# **Report of the Strategic Director Place to the meeting of Bradford South Area Committee to be held on 22nd June 2023.**

**WIBSEY PARK AVENUE & FARFIELD AVENUE, BRADFORD, TRAFFIC CALMING  
MEASURES - OBJECTIONS**

**This report considers objections received to recently advertised proposals for traffic calming measures on Wibsey Park Avenue & Farfield Avenue, Bradford.**

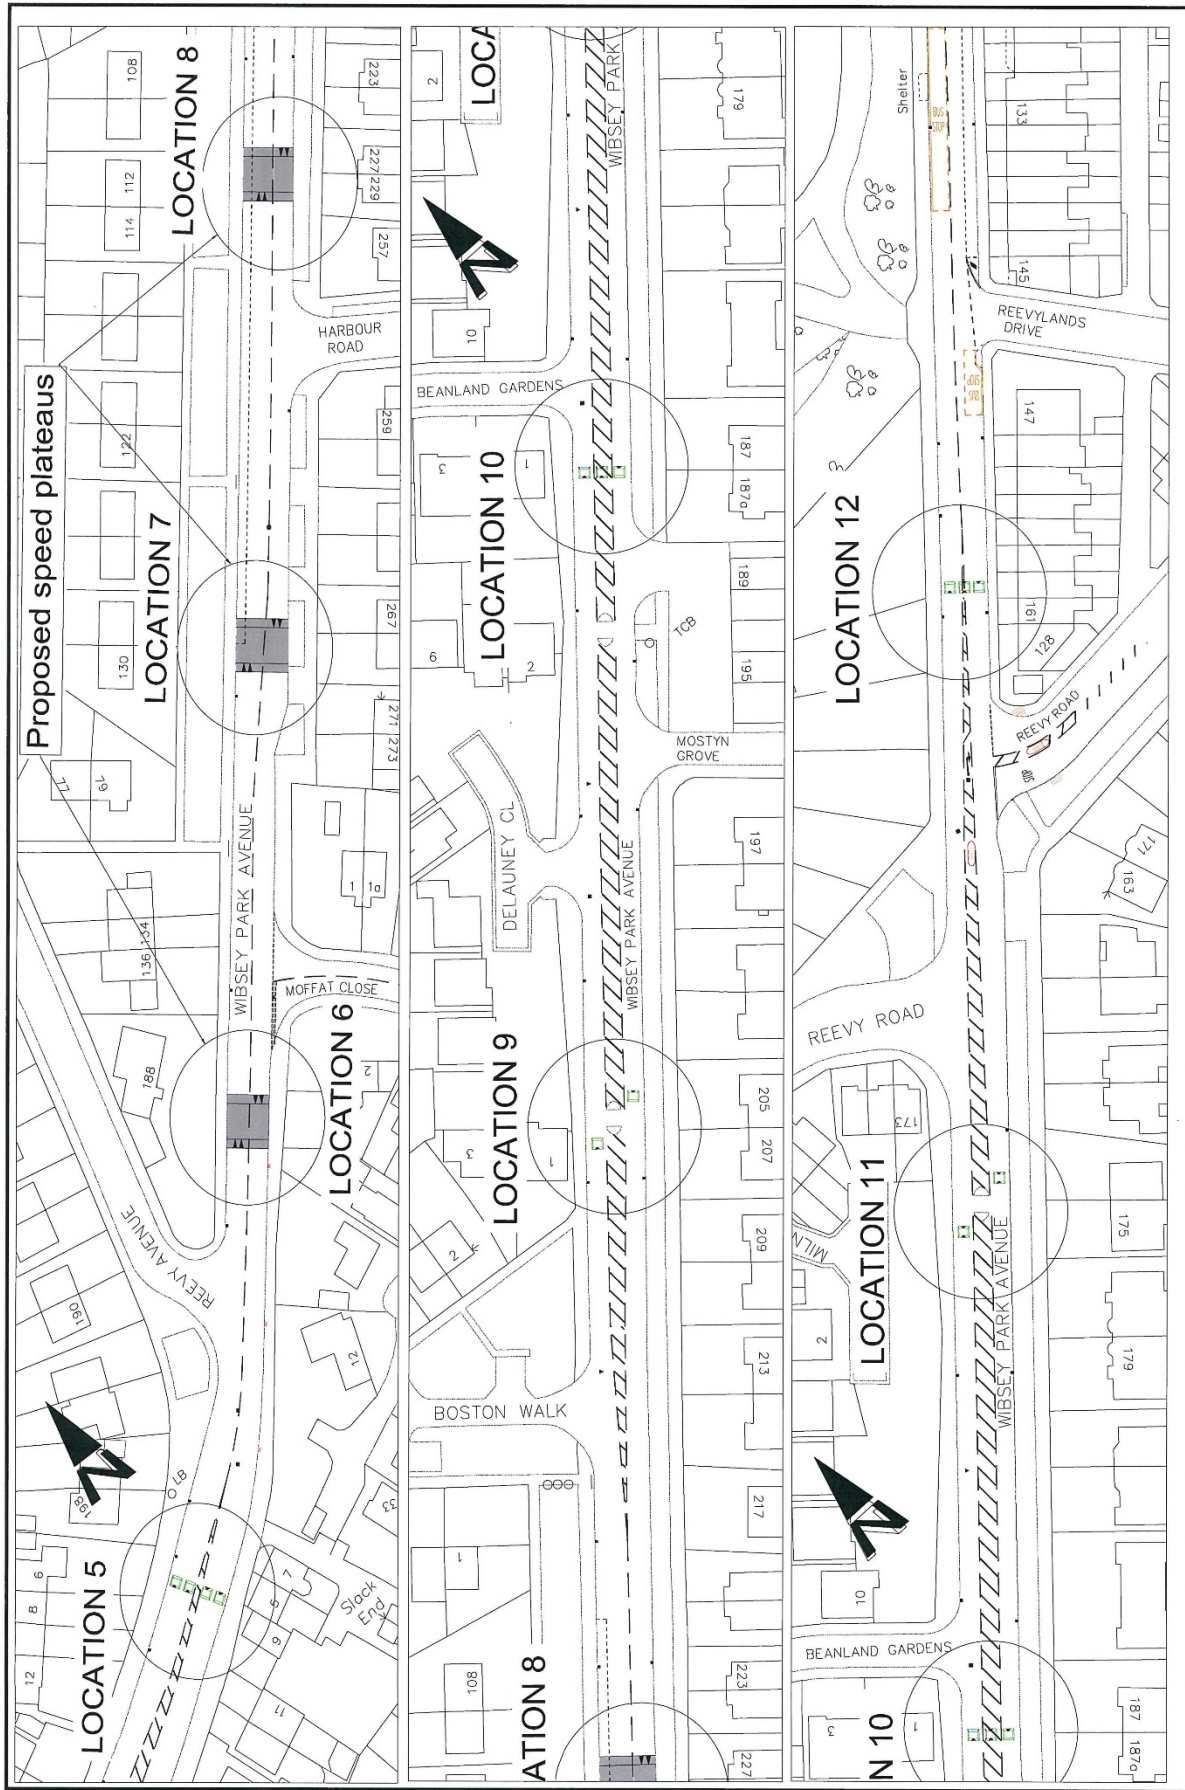
<p><b><u>Objector No. 3</u></b></p> <p>The objector states that the plans provided by you show speed humps directly outside their driveway and they oppose the location of the humps as they will impinge on access and egress to the driveway of their property. It is proposed the location of these humps be moved eastwards towards the junction at Reevy Avenue, in a location that does not affect driveway access to the properties on this section of road. There are ample locations available in</p>	<p>Following the initial consultation, a review of the location for the traffic calming feature was undertaken and was moved slightly eastwards which would avoid being directly in front of any driveways. This change is reflected in the latest drawing HS/TRSS/105399/CON-2B</p>

<p>this area to facilitate this.</p> <p>It is felt the location of the humps directly outside their driveway will have a detrimental effect on theirs and other road users' safety which is inconsistent with the intended purpose of the speed calming measures.</p>	
<p><b><u>Objector No. 4</u></b></p> <p>I have some concerns regarding the proposals.</p> <ol style="list-style-type: none"> <li>1. Increased pollution from vehicle exhausts due to decreasing/increasing speed.</li> <li>2. Increased pollution from vehicle tyres due to increased breaking.</li> <li>3. Increased noise pollution due to increase in breaking, acceleration, and driving across the speed bumps.</li> <li>4. Increased wear and tear on the vehicles used and owned by the local residents.</li> </ol> <p>Has a survey been done in regards to the above and other factors that will have an impact on the environment, animal and fauna, and local residents?</p> <p>As it stands I object to the proposals until I see a survey which highlights the negative impact the bumps may have and how that negative impact may be mitigated.</p> <p>I am also concerned with how this may impact my ability to obtain planning</p>	<p>With regards to the air quality, there have been conflicting studies as to whether traffic calming increases or decreases pollutants. However, it is advised that particular attention would need to be given to the balance between reductions in injury accidents and increases in vehicle emissions. In the previous 5 years the accident records show that there have been 12 accidents of which 2 have been serious, along Wibsey Park Avenue and Farfield Avenue. 4 of these accidents are recorded at the Reevy Road junction.</p> <p>The scheme should have a neutral impact on noise pollution.</p> <p>All traffic calming features are built to national guidelines. Vehicles travelling over road humps at appropriate speeds should not suffer damage, provided the humps conform to the Highways (Road Hump) Regulations. A study in to the effect of repeatedly traversing road humps on vehicles (Kennedy et al., 2004e) showed no damage to any of the vehicles was seen, despite repeated passes at speeds up to 40 mph. However, suspension geometry checks revealed some minor changes in the suspension systems tested. Further testing showed there was no continuing trend for the suspension to move further out of specification; but stayed within the manufacturer's tolerances.</p> <p>Officers have obtained the objectors address and there are no traffic calming features within</p>
